Cachuma Order WR-2019-0148 Term 27 Annual Compliance Report for Water Year 2020

**Cachuma Project, California
Interior Region 10 – California Great Basin**

Attachment A Water Year 2020 Lake Cachuma Daily Operations
Attachment B Water Year 2020 Annual Monitoring Report Pursuant to RPM 11 of the
National Marine Fisheries Service 2000 Biological Opinion
Attachment C Reclamation Response to Comments and Comment Letters on Draft
Term 27 Annual Report

Figure 1. Flow Chart Depicting Interlinkages between Term 24 Studies

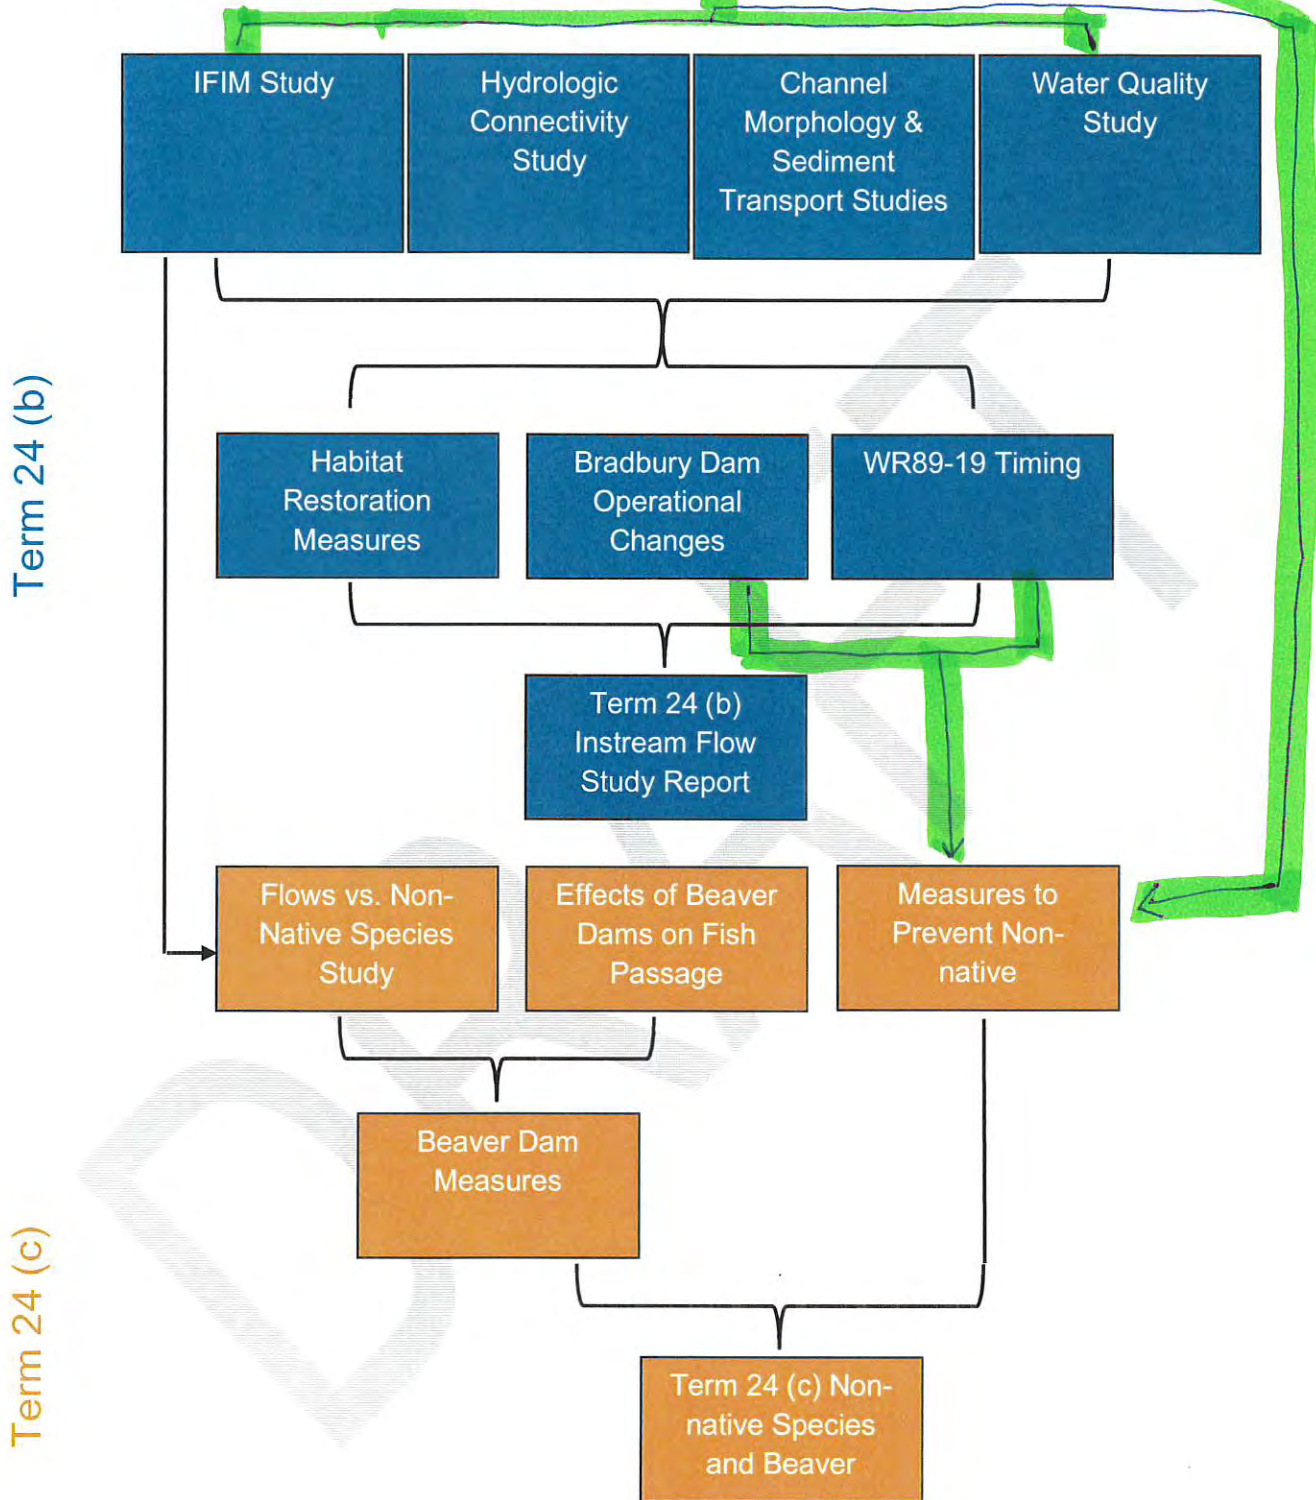
CDFW COMMENT #49: The flow chart should also show the interconnection of the top tier studies with the Term 24(c) measures to prevent non-natives (see Attachment C- CDFW recommendations on Figure 1. Flow Chart).
